Project: 3873.1
City of Minot,
North Dakota
Change Order
No. 4

Date of Issuance: <u>October 24, 2015</u>		Effective Date: <u>October 24, 2015</u>
Project: 16Th Ave, 46th St, 14Th Ave Rebuild & 16th Ave Water line	Owner: City of Minot	Owner's Contract No.: 3873.1
Contract: 16Th Ave, 46th St, 14Th Ave Rebuild & 16th Ave Water line		Date of Contract: 9 April 2015
Contractor: Wagner Construction		Engineer's Project No. R14090.01

Re: Change Order #4 – Independent Cost Estimate
Project 3873.1 - 16th Ave, 46th St and 14th Ave SE Rebuild

**RE: Change Order #4- Cost Justification for Trench Drain
Project 3873.1 - 16th Ave, 46th St and 14th Ave SE Rebuild**

City of Minot, North Dakota
16th Ave, 46th St and 14th Ave SE Rebuild
CDBG-Disaster Recovery Project
GRADING EXHIBIT

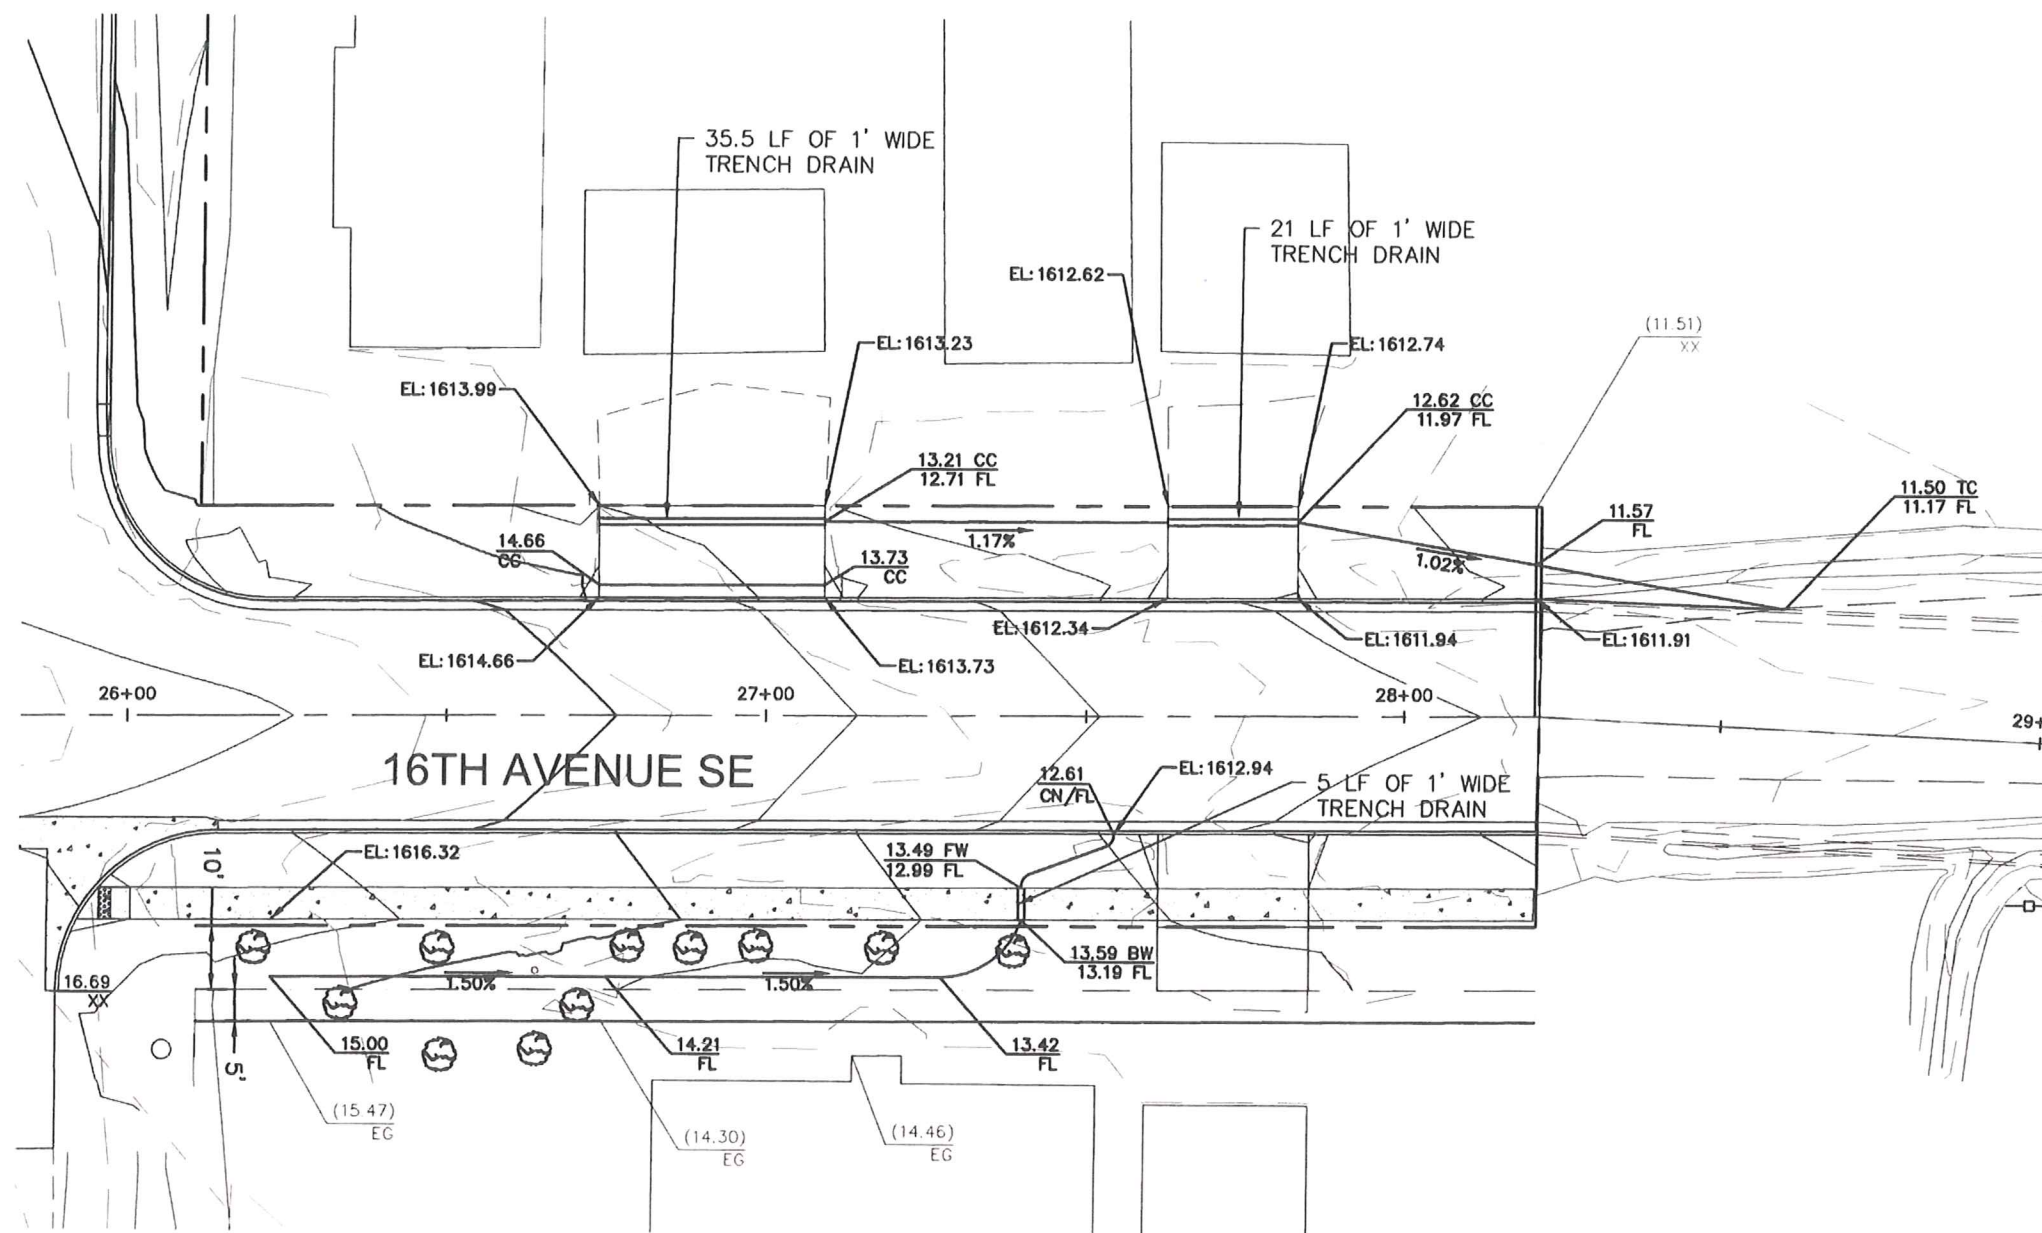
Item #1: The area on 16th Ave SE behind the curb and gutter from Sta. 26+50 to 27+60 Lt and behind the sidewalk from Sta. 26+50 to 27+60 Rt required that the water drain from west to east, across the existing driveways before existing to the roadway drainage. Due to safety and future maintain concerns of water freezing on the driveways, trench drains are to be installed across the driveways at Sta. 26+91.4 Lt and Sta. 27+72.96 Lt as well as across the sidewalk prior to the driveway at Sta. 27+73.31 Rt. Additional grading is to be completed to drain water to the project limits. The additional costs include: 64 LF of Trench Drain at the accepted unit price of \$264.50, Grading & Excavation at the accepted unit price of \$1,250.00/LS, and 10 LF of Saw Cutting at the accepted unit price of \$5.00/LF. Net effect of this revision is an increase of \$18,228.00 to the contract amount.

This independent cost analysis is for the addition of trench drains in two driveways and one sidewalk to improve the drainage of water from behind the new curb and gutter or sidewalk. The area on 16th Ave SE behind the curb and gutter from Sta. 26+50 to 27+60 Lt and behind the sidewalk from Sta. 26+50 to 27+60 Rt required that the water drain from west to east, across the existing driveways before existing to the roadway drainage. Due to safety and future maintain concerns of water freezing on the driveways, trench drains are to be installed across the driveways at Sta. 26+91.4 Lt and Sta. 27+72.96 Lt as well as across the sidewalk prior to the driveway at Sta. 27+73.31 Rt. Additional grading is to be completed to drain water to the project limits.

Proposed Trench Drain to be installed at driveways located at 46th St Se & 16th Ave Se. There will also be an additional 6' installed at the sidewalk.

Trench Drain is a 12" Solid Plate provided by Neenah Foundry (Plate Number R4990CX)

The proposed plates come in (2' Sections). The length of the trench drain was recalculated to be 58' for both driveways
